Draft White Paper

RESPONSE TO “BATTELLE-TBD-6000 APPENDIX BB GENERAL STEEL INDUSTRIES: DOSE ESTIMATES FOR BETATRON OPERATIONS”

March 2012

Figure 1. Sketch of New Betatron Building, Showing ⁶⁰Co Source and Lead-Lined Double-Leaf Door (NRC 2009a)

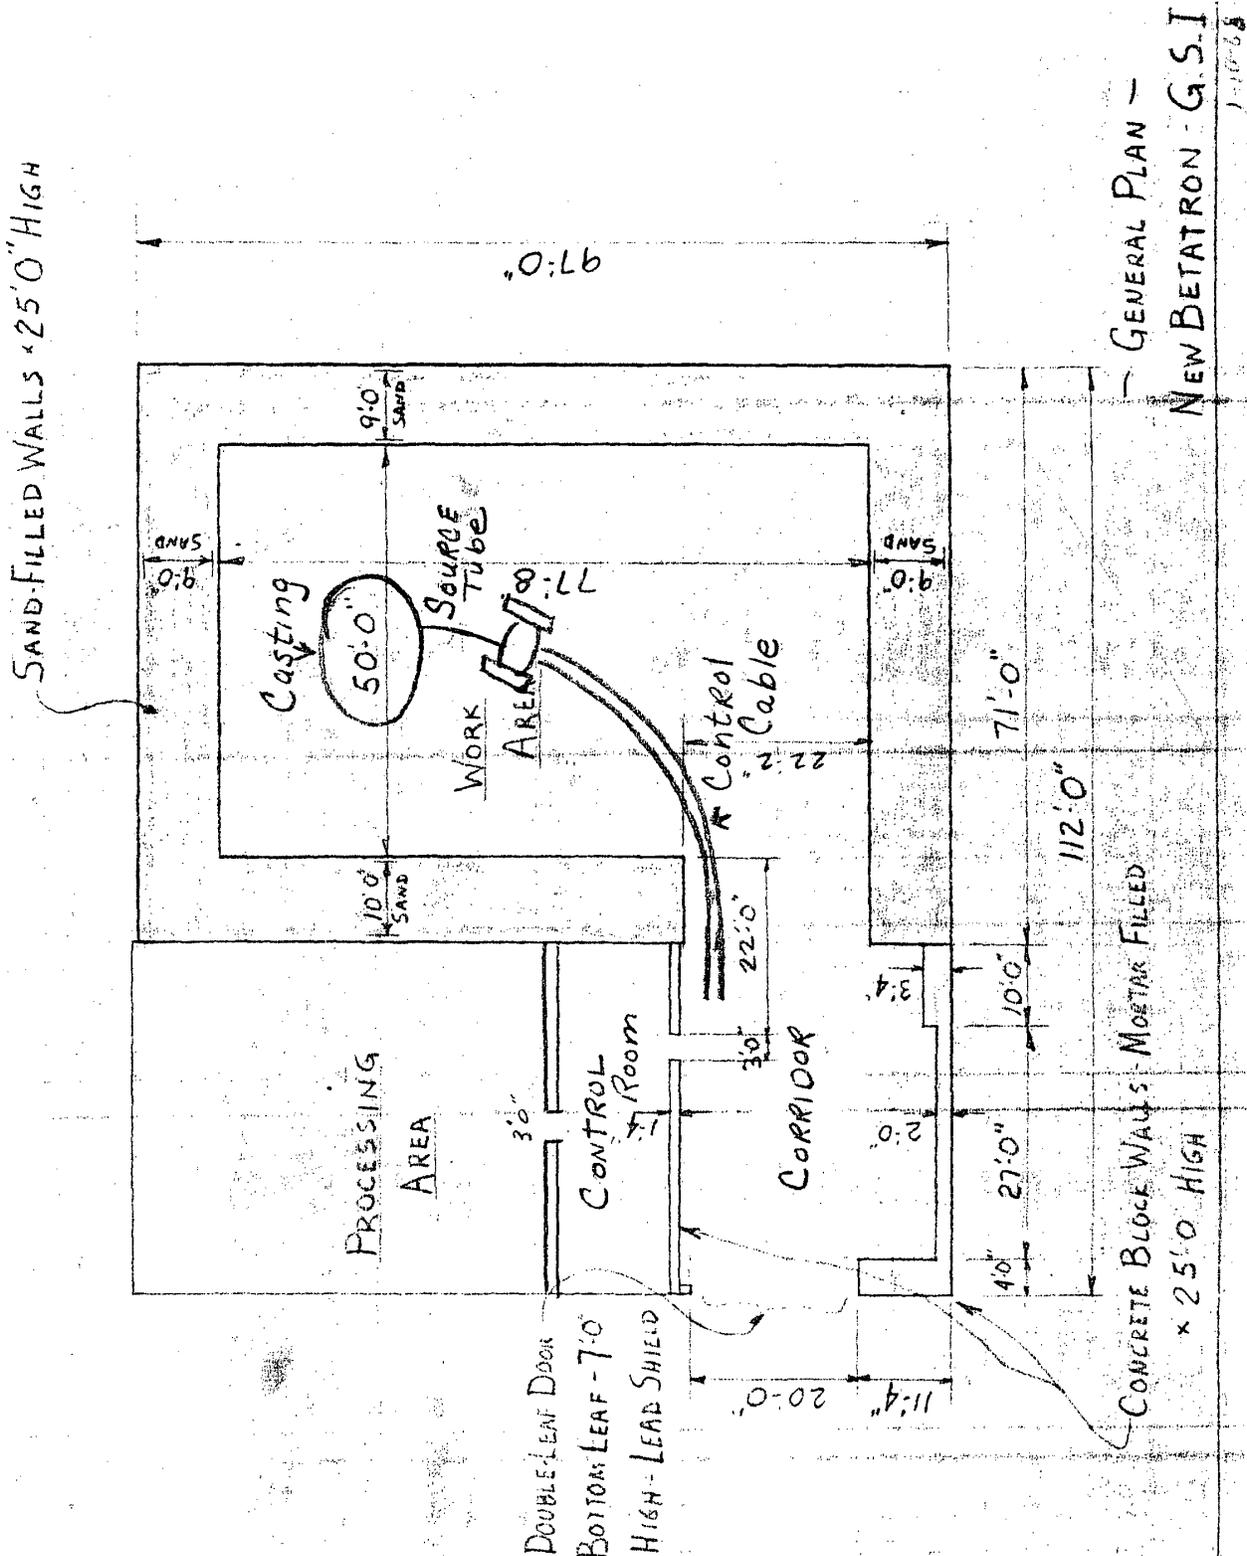
Our first observation addresses Allen’s (2012) assumption about a lead-shielded double-leaf door separating the New Betatron Building from No. 10 Finishing Building. The earliest reference to such a door is in a hand-drawn sketch of the New Betatron Building, shown here in Figure 1, that is dated January 10, 1968 (NRC 2009a), and is apparently part of the AEC license application for the 80-Ci ⁶⁰Co source, transmitted with a cover letter dated January 15, 1968 (NRC 2009b).

Figure 2. Architectural Drawing of New Betatron Building, Showing Lead-Lined Double-Leaf Door (NRC 2009c). Arrow indicating north added by present authors.

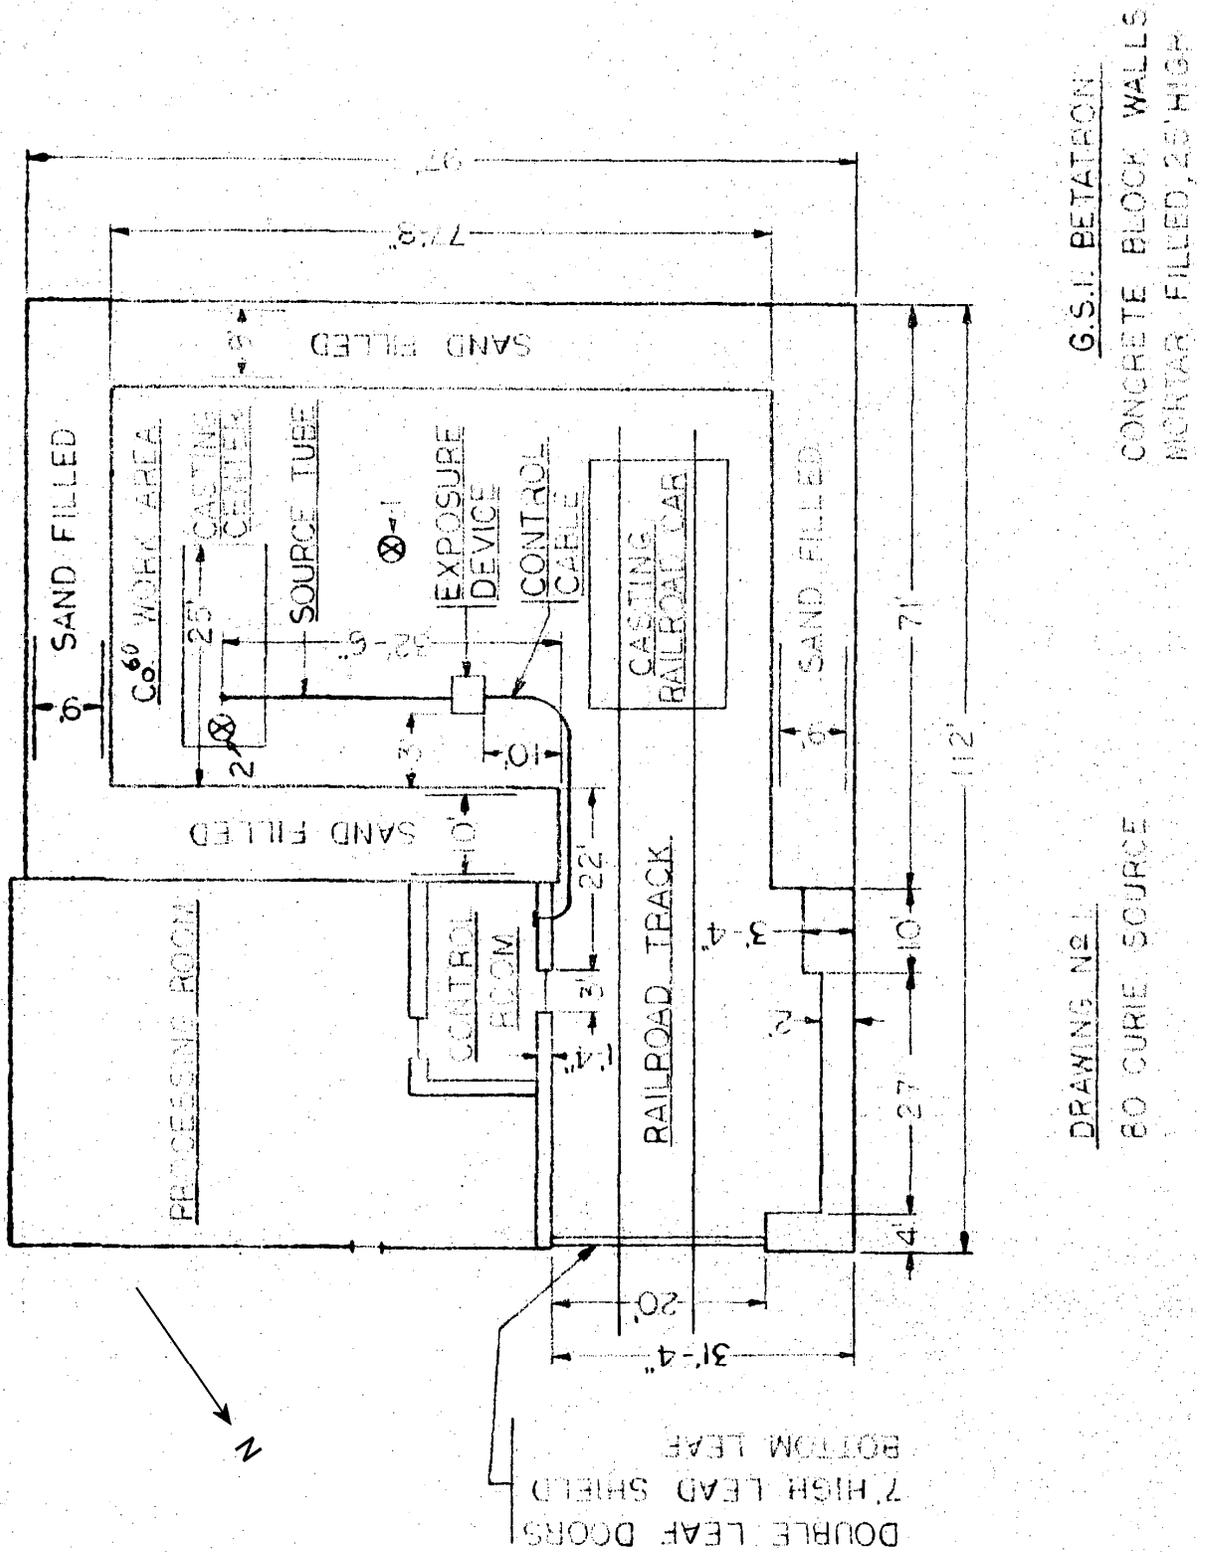
It is therefore plausible that the lead-lined door was installed in the New Betatron Building some time after the building was erected. It could have been installed ca. 1968 to facilitate AEC approval of the license for the 80-Ci ⁶⁰Co source. Since there is no direct evidence that the lead shield was present during the operational period and there is worker testimony that it wasn't, the analysis of radiation exposure levels outside the New Betatron Building should be based on the claimant-favorable assumption that the door was made of thin sheet metal.

Allen (2012) next placed the casting and the betatron in two other locations in the shooting room. First, he located the casting near the southwest wall, away from the control room (the wall is shown at the top of the page in Figure 2). Here, he utilized three betatron orientations: perpendicular and 45° to the right and left, all in the horizontal plane. Finally, he placed the casting along the southeast wall (left side of the page in Figure 2), where he aimed the betatron in the same three directions; in addition, for the 45° to the left position, he rotated the beam 45° above and below the horizontal.

Figure 4. Drawing of New Betatron Building Showing Desk in Control Room (NRC 2009c)

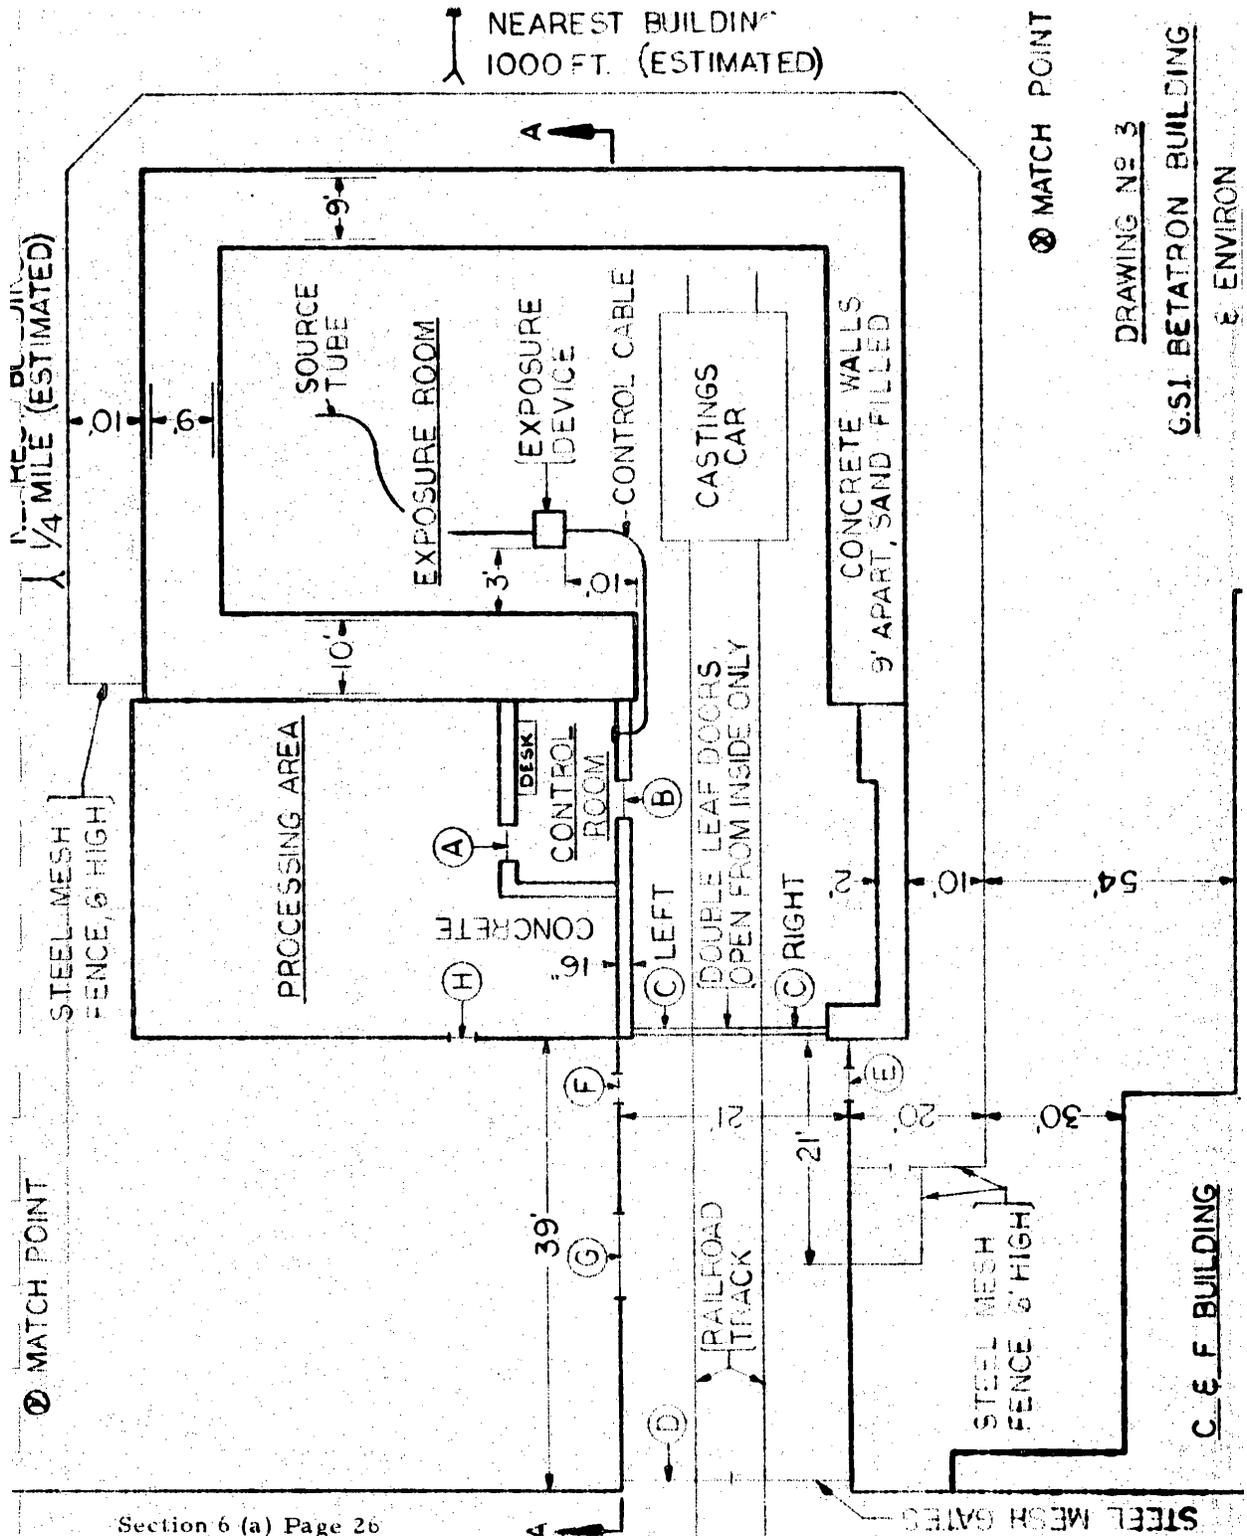
For each scenario, Allen (2012) calculated the exposure rate at each of 10 locations inside and outside the betatron building. One of these locations was the desk in the control room, shown here in Figure 4. He then postulated that Film Badge No. 001, given the name “Betatron Ctl” in the weekly Landauer film badge dosimetry reports, was stored in this location. Since the report for this badge was always *M* (minimal), and since Landauer claimed the minimum detectable level (MDL) of 10 mrem for the film badges, Allen assumed that the badge received a limiting dose of 10 mrem during each weekly cycle. Since, according to Allen’s calculations, the betatron operated 69.89 hours per week, the average hourly dose rate to the badge was 0.143 mrem. He then used the Excel Solver function to select two out of the 15 scenarios and divided the total exposure duration of the betatron between these two scenarios such that the weighted average exposure rate (which he equated to the dose rate) equaled 0.143 mR/h at the location of the desk. To determine the weekly exposure at each of the aforementioned locations, he multiplied the exposure rate from each of the two selected shot scenarios by the fraction assigned to that scenario by the Excel Solver function.

Our second finding involves the assumption regarding the control room film badges. Except for the laconic title “Betatron Ctl,” there is no information regarding where this badge was stored. No former employees who handled the film badges are known to be available. Consequently, there is no reliable information that would place Film Badge No. 001 in the control room desk or in any other identifiable location.

Figure 5. Floor Plan of New Betatron Building, Showing Location of Rack for Storing Film Badges. (Original drawing from Murray and Uziel 1992—entries in red by present authors)

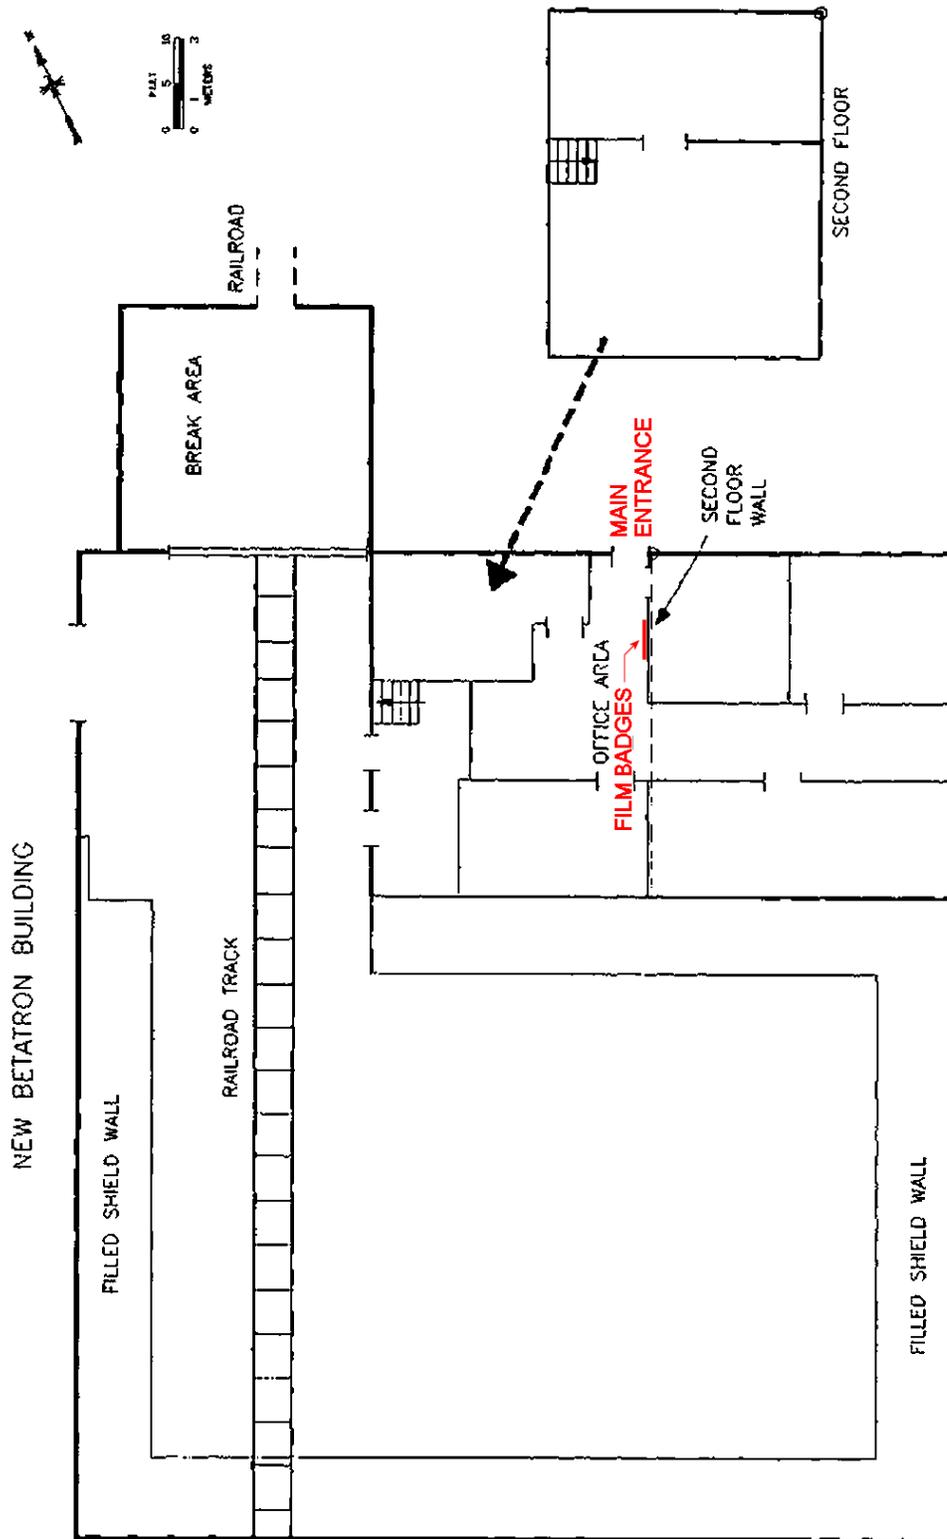
Allen (2012) assumed that the film badges of the betatron operators were stored in the control room and were thus exposed to stray radiation from the betatron, whether or not they were being worn by the workers. He concludes that the maximum dose to a worker was less than the MDL of 10 mrem because part of this dose was accumulated while the worker was off duty. This assumption is based on two errors. The first is that, while former GSI workers reported that the badges were stored in the New Betatron Building, they were not kept in the control room. According to [redacted], a former betatron operator, they were stored in a rack that was mounted on the wall of a hallway just past the main entrance to the building, as shown in Figure 5. The location of the rack is based on a detailed description by Mr. [redacted].⁴ The second error is failing to account for the unnumbered control badge (not Badge No. 001: Betatron Ctl) that was included with each batch of film badges sent to GSI by Landauer. As an

badges of off-duty workers. It is returned to Landauer along with each batch of film badge dosimeters, where all the films are developed in a single batch and read with an optical densitometer. The control badge determines the background—in the terminology of an analytical laboratory, it constitutes a blank. According to Joseph Zlotnicki, CHP (former Landauer official, currently a member of the SC&A staff): The assigned dose is determined by subtracting two numbers that are derived from the density on the user film and the density on the background or “blank.” (SC&A 2011) Thus, any doses in the film badge dosimetry report represent the doses received by the worker while wearing the badge, not while it was stored in the rack. Allen’s estimate of the dose to the betatron operators, derived by subtracting the assumed exposure of the badge while the operators were off duty, is thus incorrect.

SC&A has reassessed the exposures of unbadged workers to radiation from the betatron, using the updated room geometry and new information on the operation of the betatron. Given the numerous types of castings and exposure geometry, we still consider our original exposure geometry (what Allen, 2012, calls a “straight” shot) to lead to a reasonable upper-bound exposure. One result of the new assessment, based on the updated model of the New Betatron Building, is that the restroom that abuts the No. 10 Building was no longer a location with a high exposure potential. This is because of the walls opposite the control room shown in the lower right-hand corner of the page in Figures 1, 2, and 4 that do not appear in Figure 5, which was the basis of our earlier model.
